ADDITIONAL INFORMATION Reg. Ref. SD22A/0126

Re: **ADDITIONAL INFORMATION Reg. Ref. SD22A/0126**

Project: Proposed Residential Development at Grange Road, Rathfarnham, Dublin 14
 Job No.: 2020_134
 Drawing Series: Additional Information Reg. Ref. SD22A/0126

PLAN

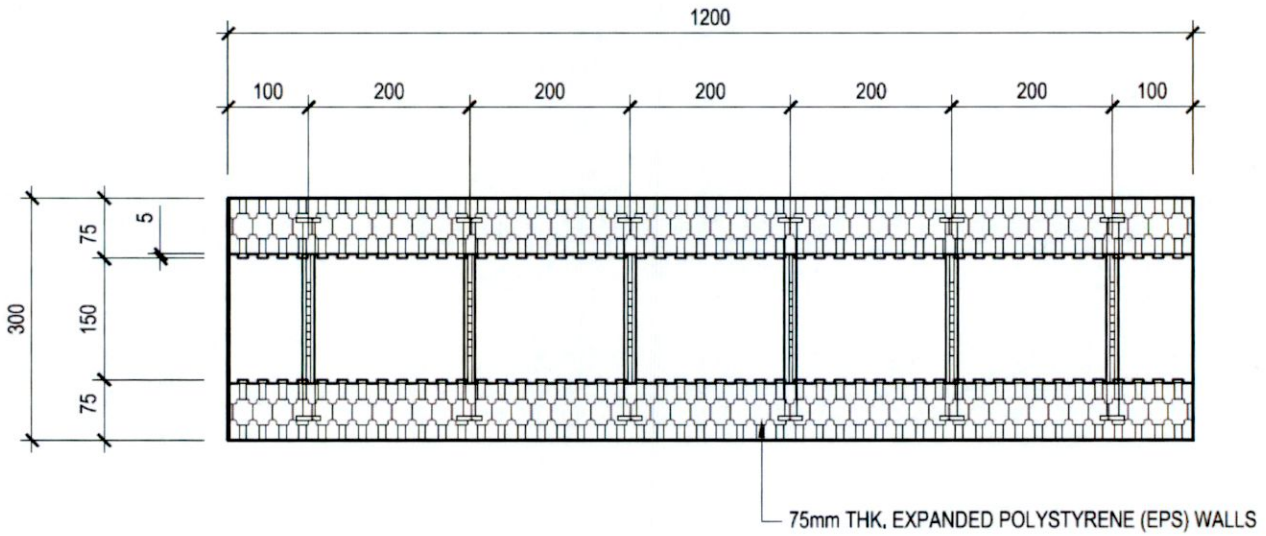
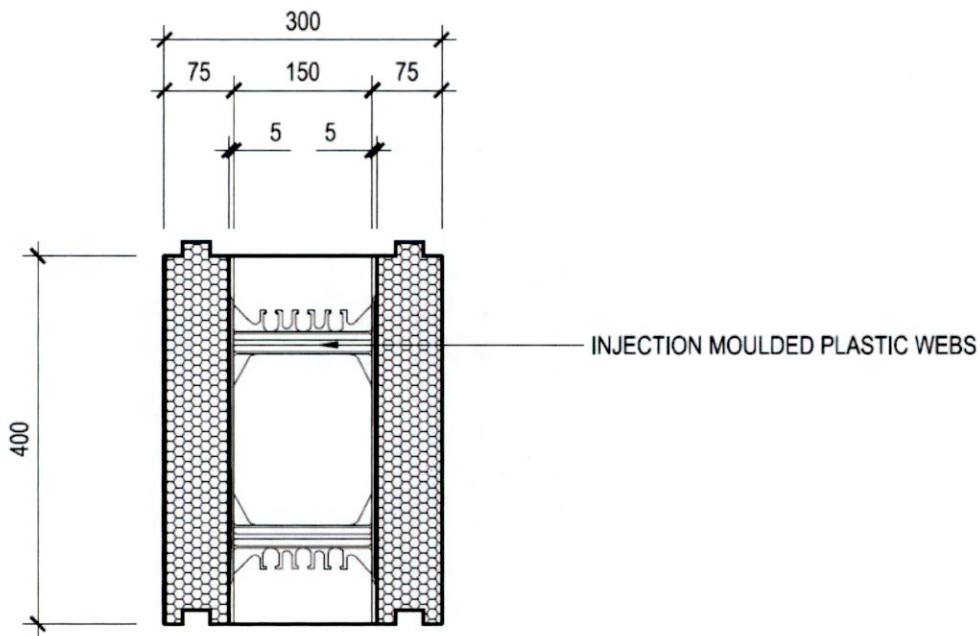
- (a) *The proposal would raise the building's parapet height by approx. 0.5 metres. The applicant's drawings are labelled to suggest that the prior permitted parapet height was 60.35m OD, but this would appear to be referring to a lift overrun. The applicant should provide a rationale for the proposed increase in height – why is it necessary – by way of additional information.*
- (b) *The increase in parapet height should be noted in revised notices.*

The proposed increase in height is necessary due to the modular system of construction proposed by the building contractor i.e., the use of Insulated Concrete Forms (ICF) modules. This has increased the height of each floor as these ICF modules only come in particular sizes. Please see plan and section of ICF below. This method of construction is proposed to ensure highest level of energy efficiency.
